**ADDENDUM NO. 3**

IRONDALE FIRE STATION No. 3

THIS ADDENDUM FORMS A PART OF THE CONTRACT DOCUMENTS. THE FOLLOWING CONDITIONS TAKE PRECEDENCE OVER ANY CONFLICTING CONDITIONS IN THE DRAWINGS AND SPECIFICATIONS. THE DRAWINGS AND SPECIFICATIONS ARE HEREBY AMENDED IN THE FOLLOWING PARTICULARS.

**5** WALL SECTION- GUARDRAIL  
 A5.03 1/2" = 1'-0"

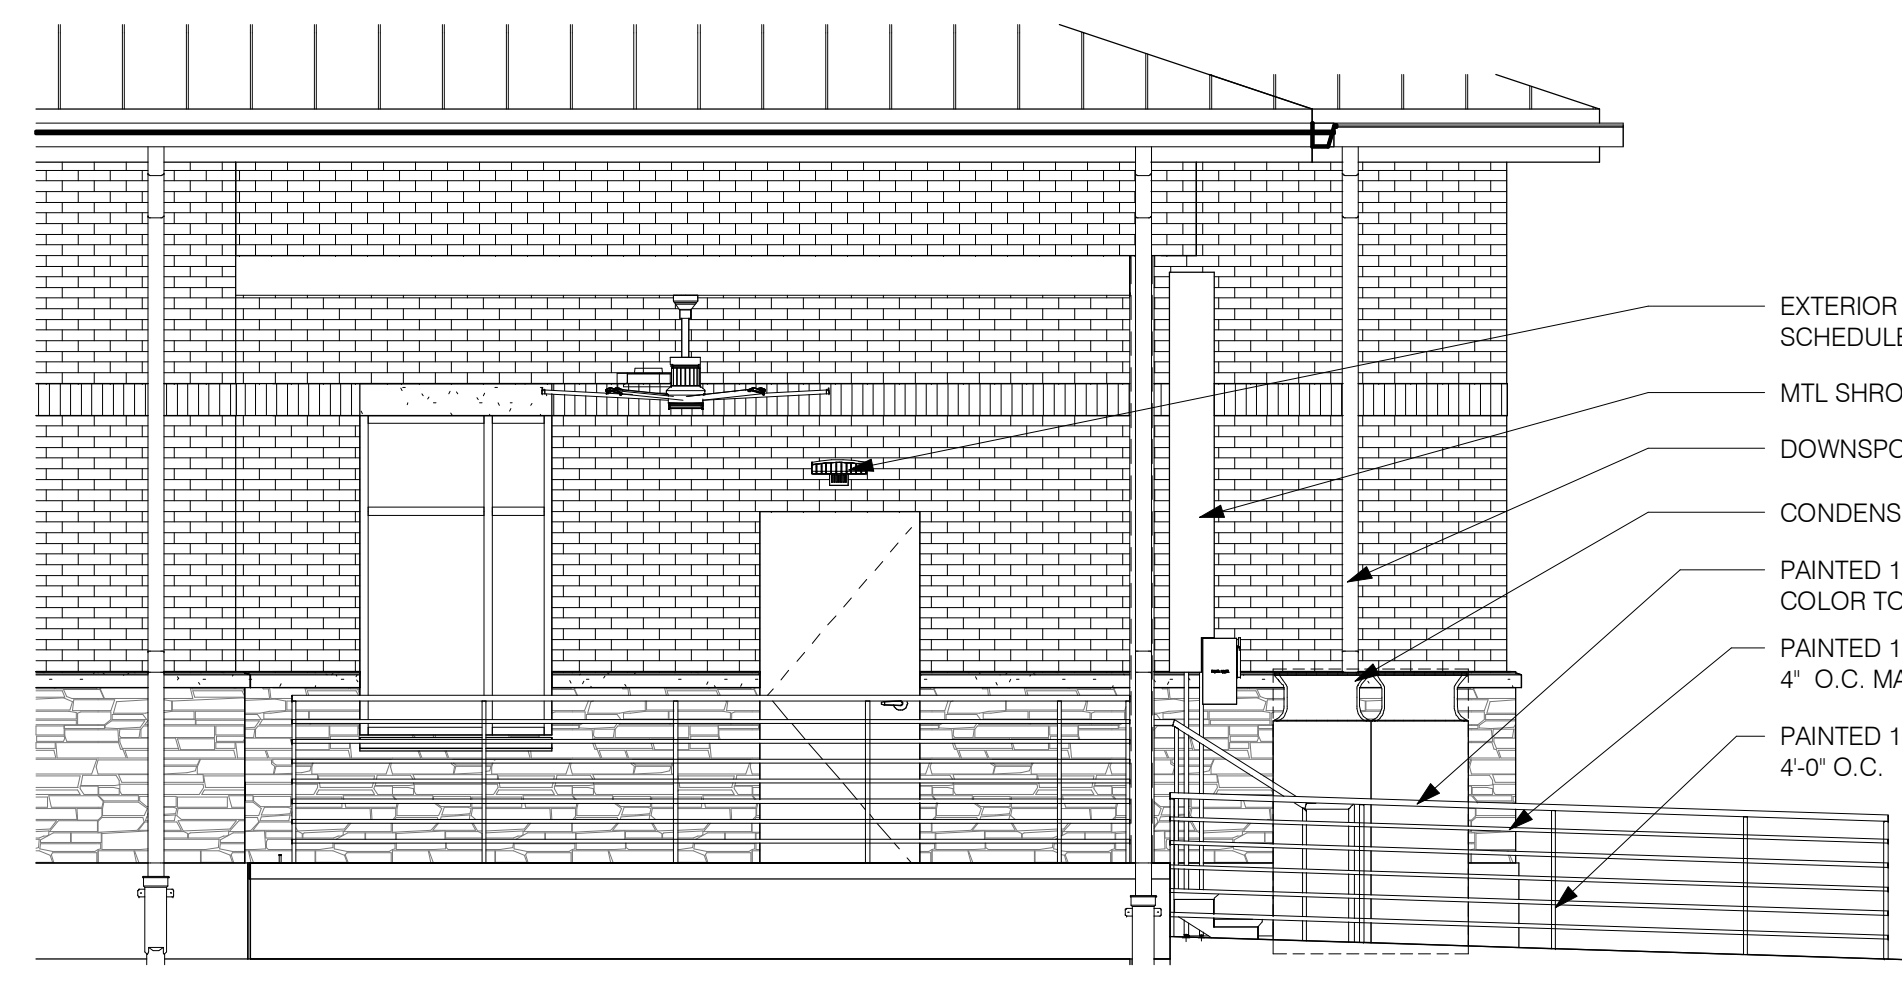
14. A5.03 Stair Details: Added section detail of guardrail at east retaining wall
15. A6.01 Exterior Elevations: Added elevation of guardrail at east retaining wall

22. Sheet C1.0 shows two (2) retaining walls at the building with notes referring to the Architectural Plans for information on the guardrail at the top of the wall. These

*retaining walls are not shown in the Architectural Plans. Please provide information on the type guardrail needed at the tops of these walls.*

Answer: See revised A2.01, A5.03, and A6.01

**COMBINATION FLUE/INTAKE CAP**  
 NO SCALE

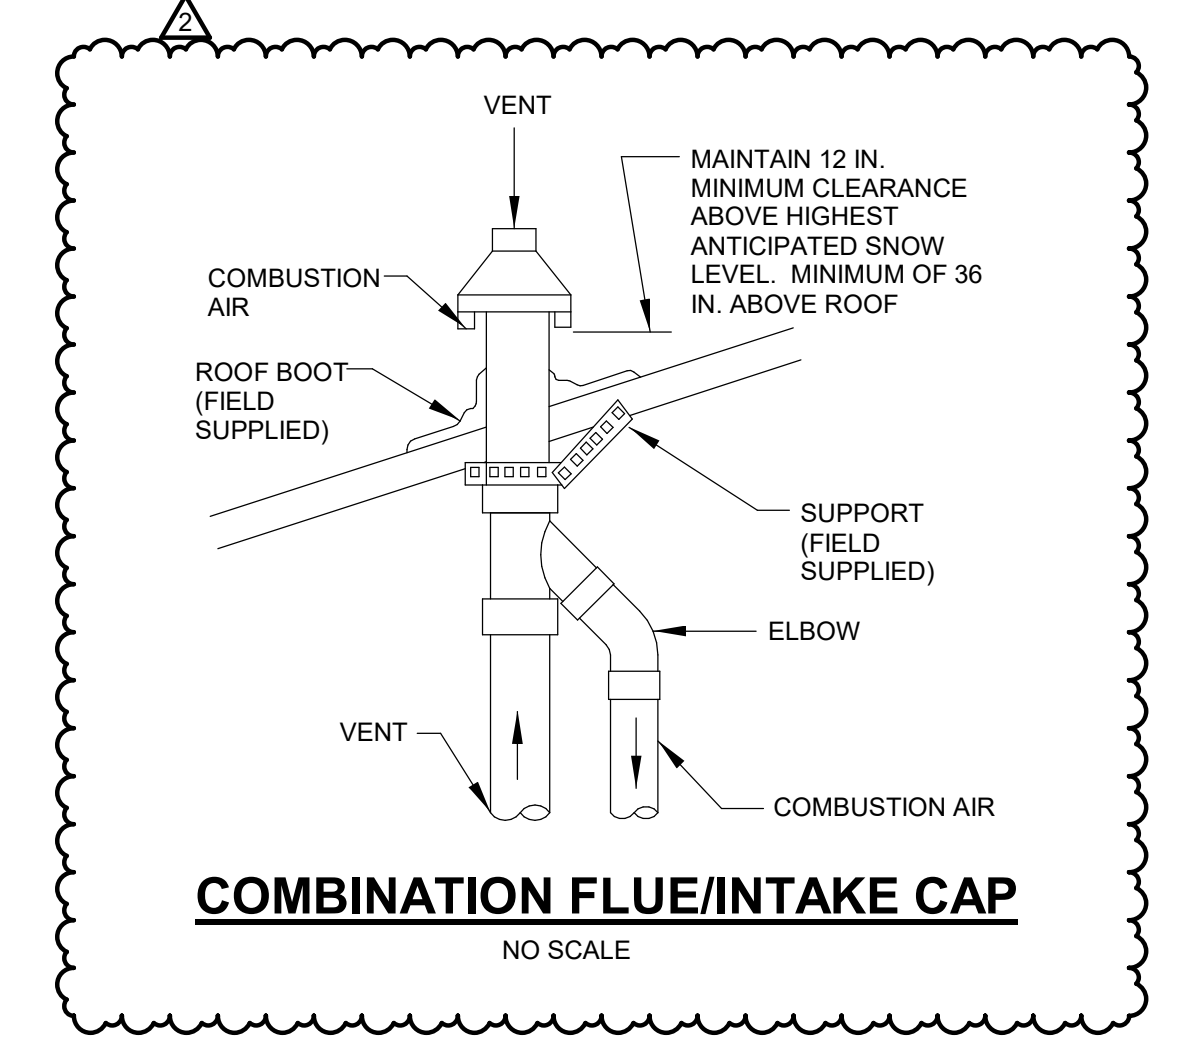
19. M0.5 Mechanical Controls & Details: Added flue / intake cap detail
20. M1.1 Mechanical Floor Plan: Added flue and intake pipes
21. M1.2 Mechanical Roof Plan: Added concentric flue for hot water heaters

SHEET NUMBER: **P0.2**

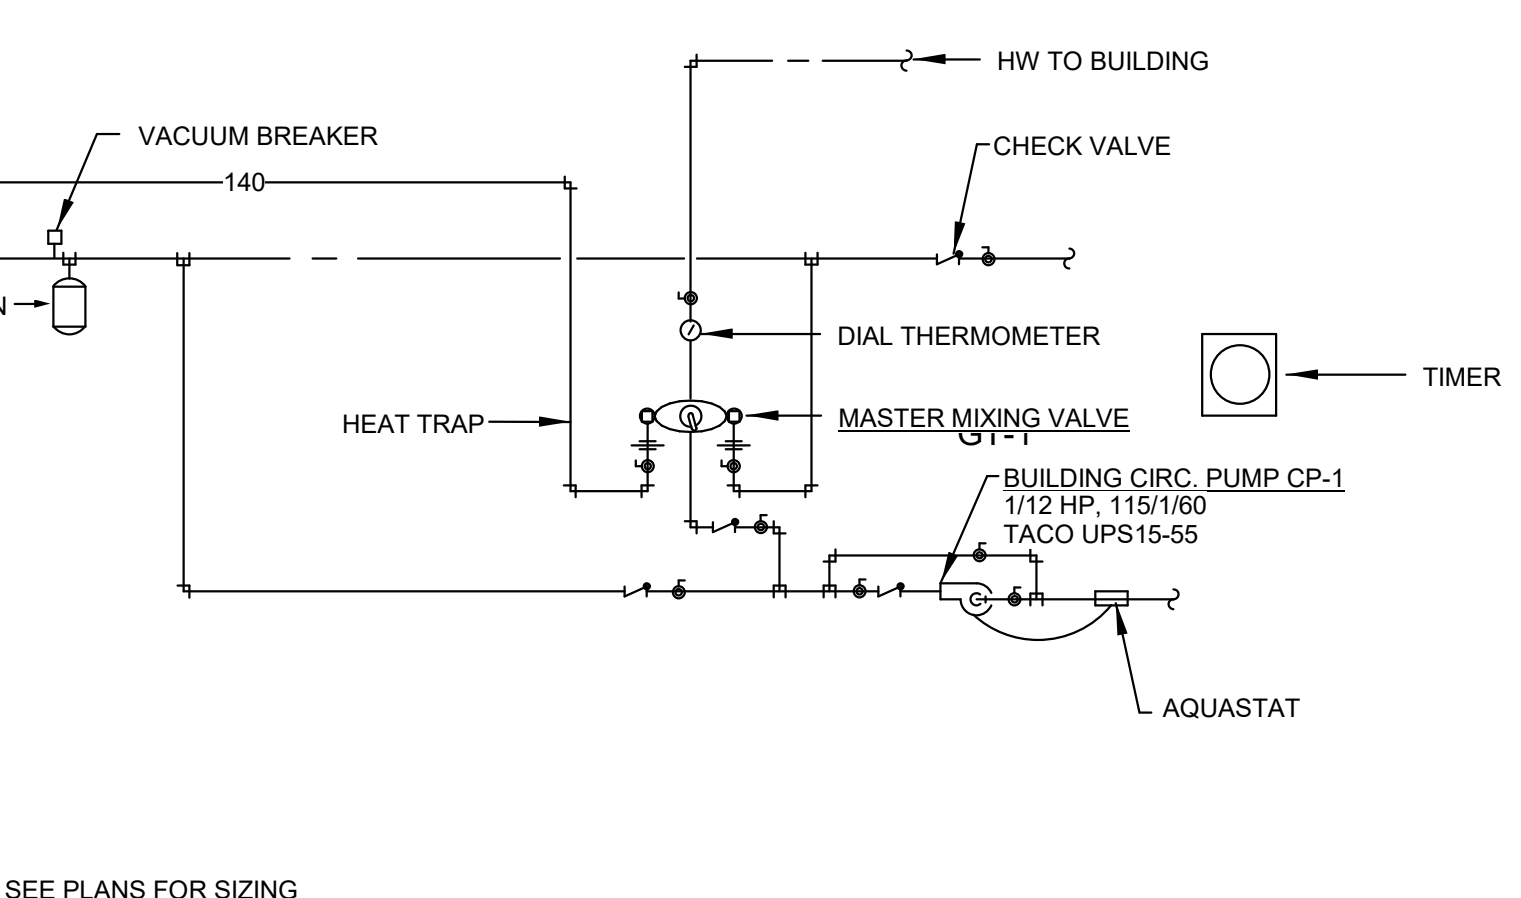
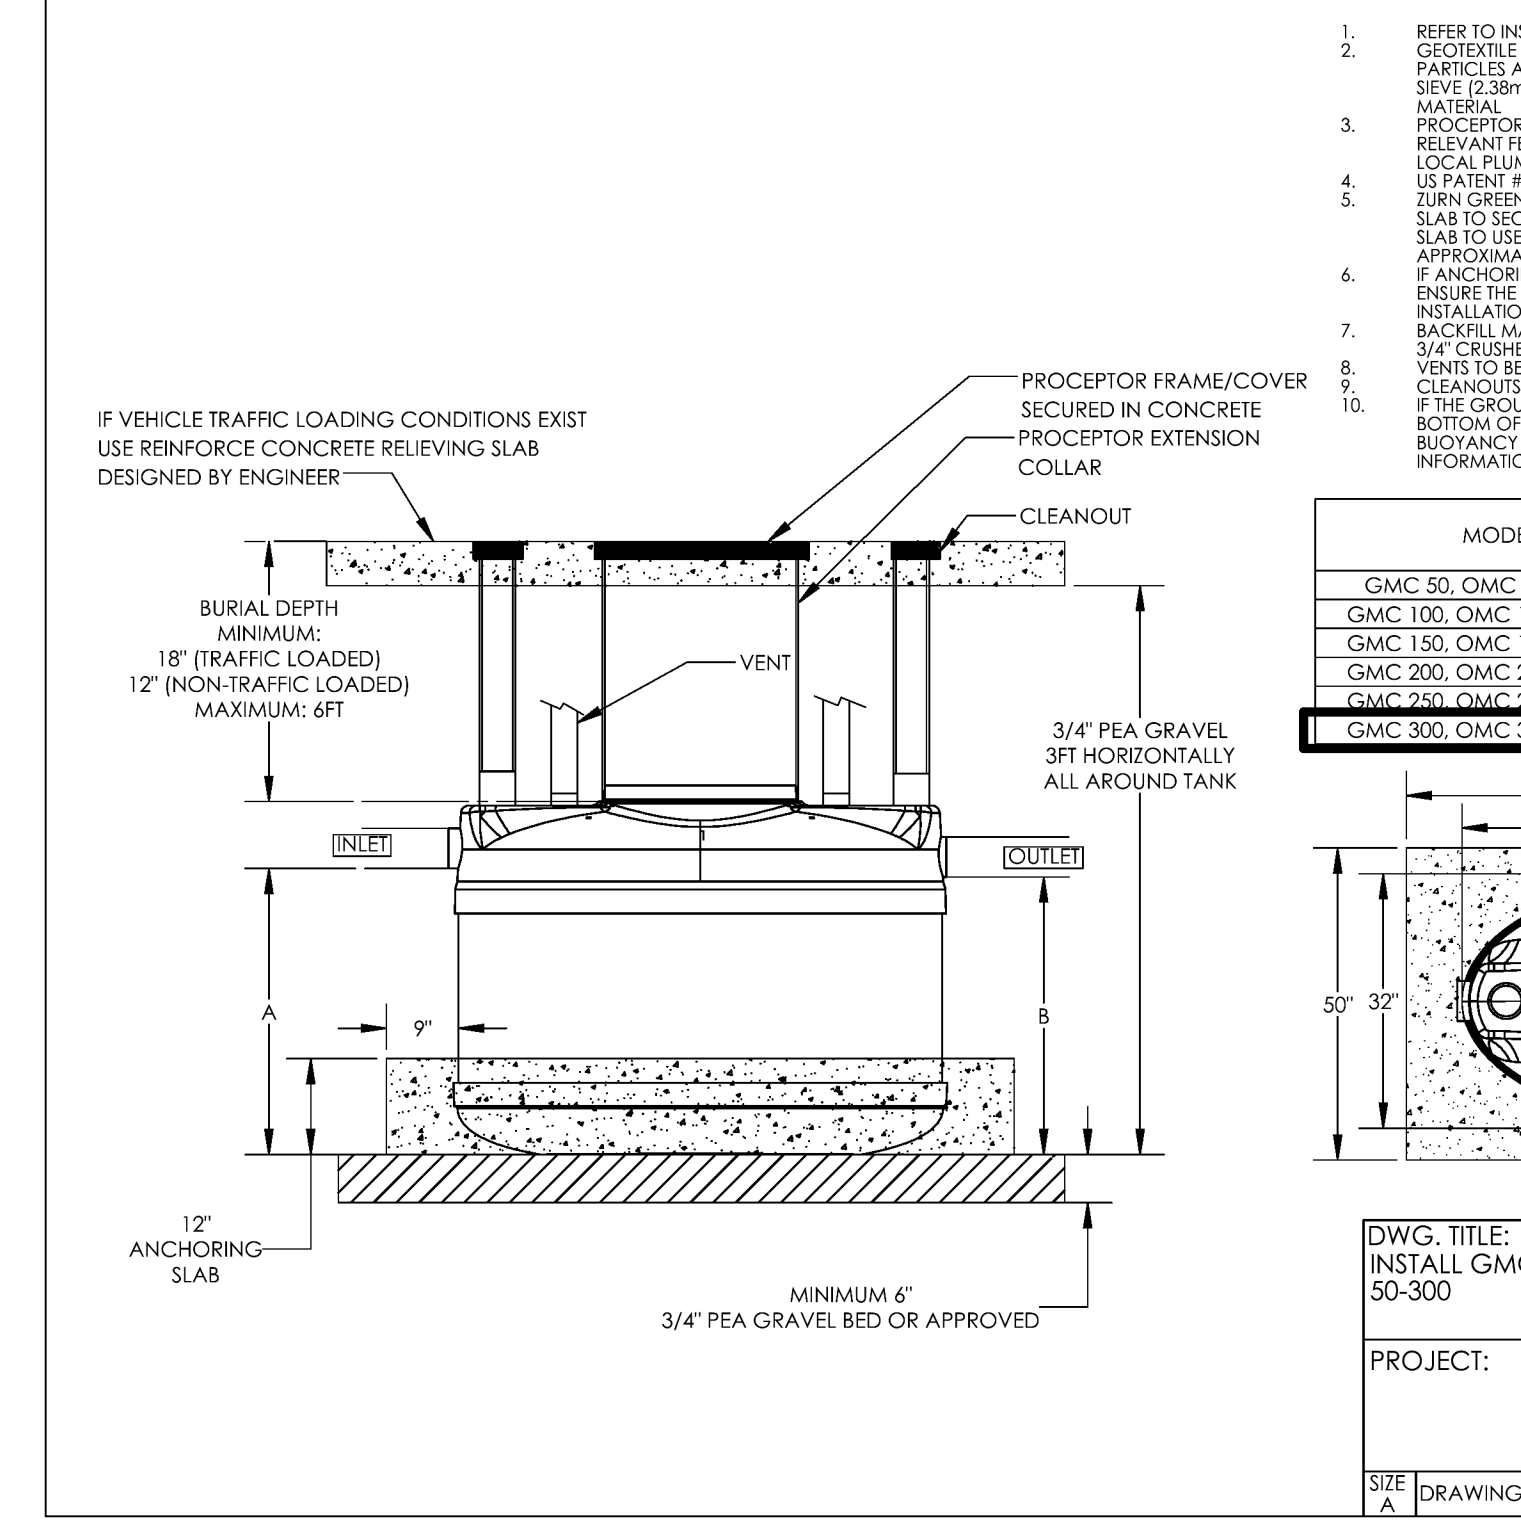
22. P0.1 Plumbing Schedules and Notes: Edited P-4, P-5, P-7. Changed WH-1, WH-2, WH-3 to gas
23. P0.2 Plumbing Details: Added water heater specification

SHEET NUMBER  
**P2.1**

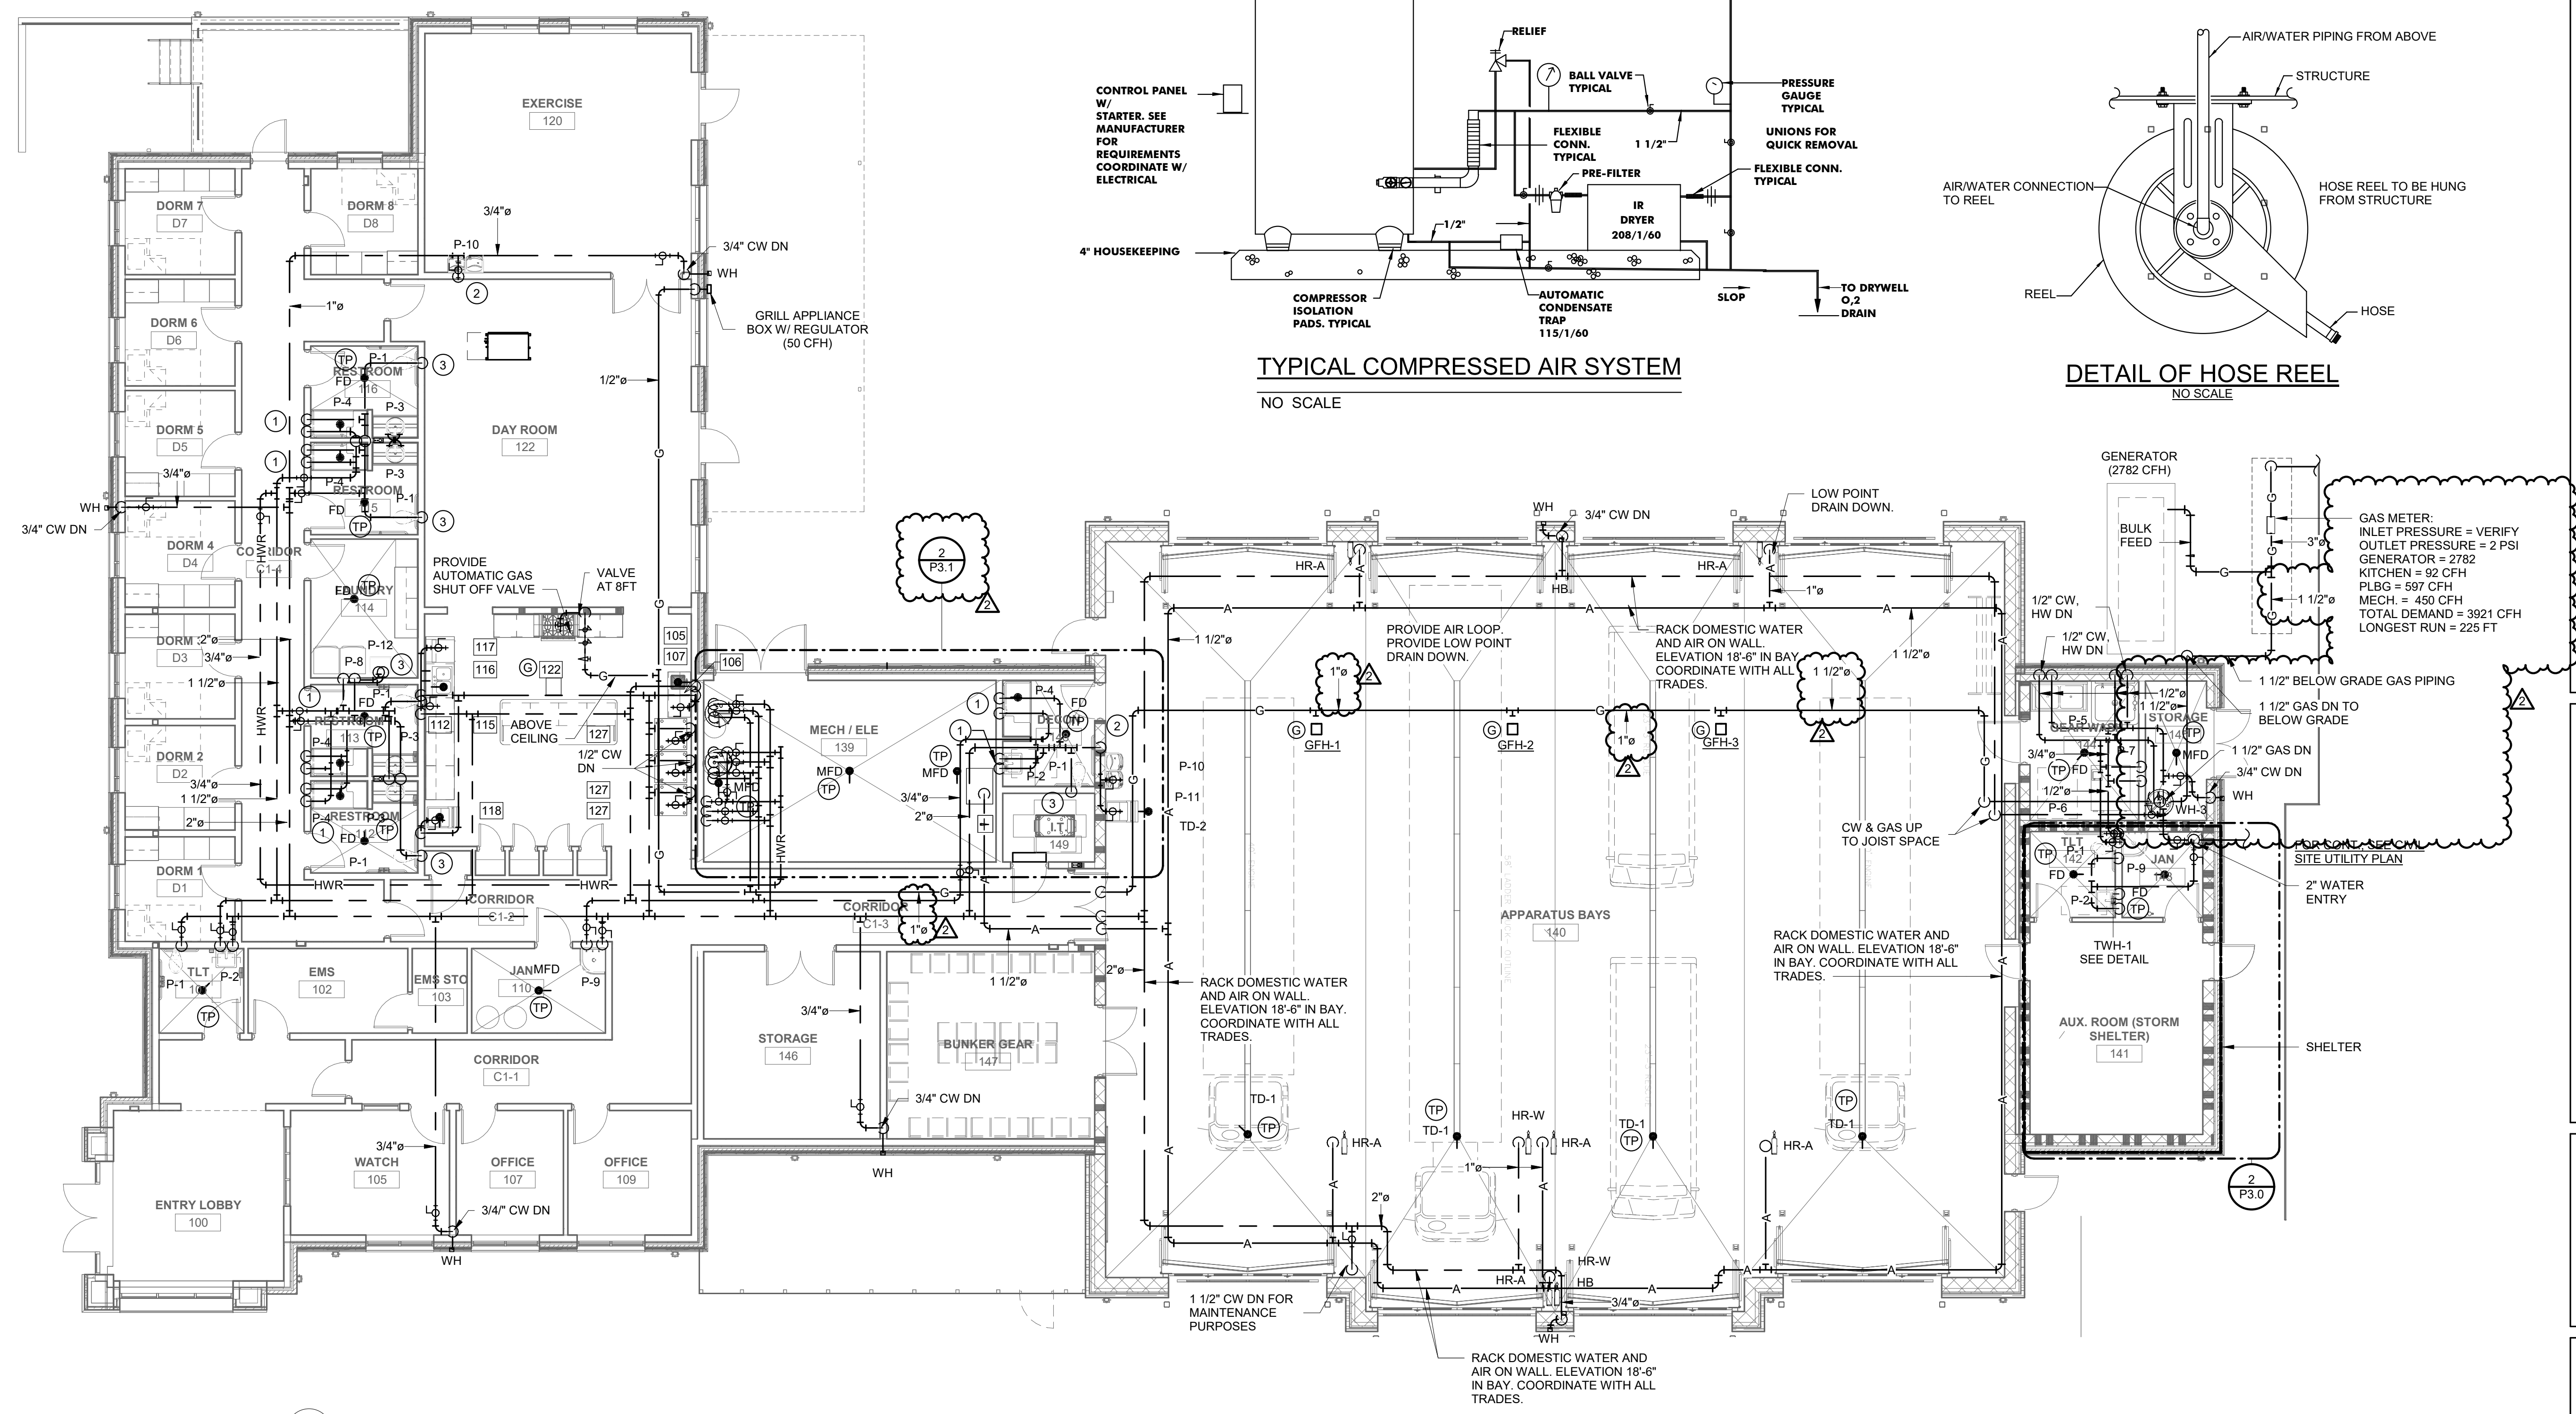
24. P2.1 Pressure Piping – Floor Plan: changes related to switching to gas hot water heaters
25. P3.1 Plumbing – Enlarged Plans: Edited layout in Pressure Mech Room Plan
